Access Compliance Report

Public Rights-of-Way

(Curb Ramps)

Intersection ID: 8616	Main Street: BEATTIES_FORD_RD	Cross Street: ST_MARK_ST	Location: SE
ADA ID: D57C131570A2	Ramp Type: BlendTrans1	Initial Pass/Fail: Fail	Overall Compliance: No
Codes/Mitigation Info/Possible Solution			Severity Score: 10
			Field Measurements/Component Compliance

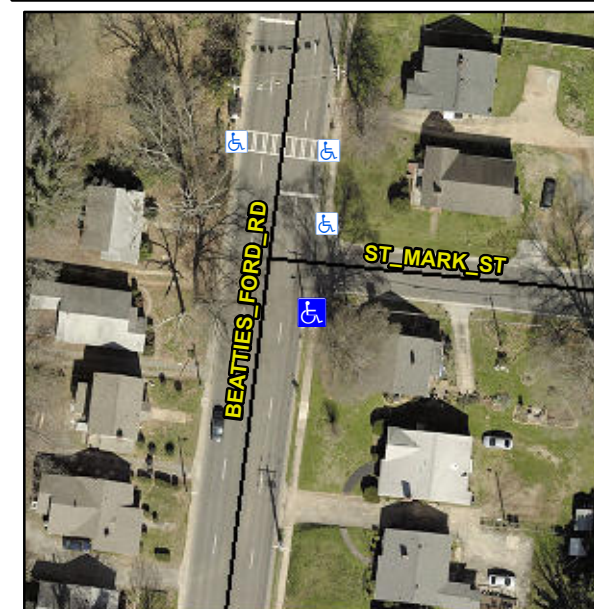
NO LT SW

Not Found, R304.5.1, R304.5.3

Compliance	Description	Data	Compliance	Description	Data
N/A	Ramp Length (in)	26.0	Yes	BlendTrans Slope (%)	4.5
No	Ramp Width (in)	47.5	No	BlendTrans XSlope (%)	4.6
N/A	Flare Type LT	N/A	N/A	Flare Type RT	N/A
N/A	Flare Slope LT (%)	N/A	N/A	Flare Slope RT (%)	N/A
N/A	Flare Traversable LT?	N/A	N/A	Flare Traversable RT?	N/A
N/A	Landing Length (in)	N/A	N/A	DWS Provided?	N/A
N/A	Landing Width (in)	N/A	N/A	DWS Contrast?	N/A
N/A	Landing Slope (%)	N/A	N/A	DWS Length (in)	N/A
N/A	Landing X Slope (%)	N/A	N/A	DWS Full Width?	N/A
N/A	Landing Curb? (Y/N)	N/A	N/A	DWS Offset (in)	N/A
N/A	Shared Landing?	N/A			
N/A	Gutter Ponding?	N/A	N/A	Gutter Slope (%)	N/A
N/A	Gutter Lip Ht (in)	N/A	N/A	Gutter X Slope (%)	N/A
N/A	Painted X Walk1?	No	N/A	Painted X Walk2?	N/A
	X Walk 1 Direction	To N		X Walk 2 Direction	N/A
	X Walk 1 Width (in)	N/A		X Walk 2 Width (in)	N/A
	X Walk 1 Slope (%)	1.9		X Walk 2 Slope (%)	N/A
	X Walk 1 X Slope (%)	8.0		X Walk 2 X Slope (%)	N/A

N/A	Ramp inside XWalk1?	N/A	N/A	Ramp inside XWalk2?	N/A
	Road Slope (%)	8.0		Clear Space?	N/A
	Road X Slope (%)	1.9	N/A	Clear Space to XWalk (in)	N/A
N/A	Any Obstructions?	N/A	N/A	Storm Grate/Utility Hazard?	N/A
	Obstruction Type			Storm Grate/Utility Type	
		N/A			N/A
			Yes	Surface Condition? (G/P)	Good
			No	Curb Slope (%)	17.3

Remove & Replace Curb Ramp With Two New Directional Ramps or Equivalent.
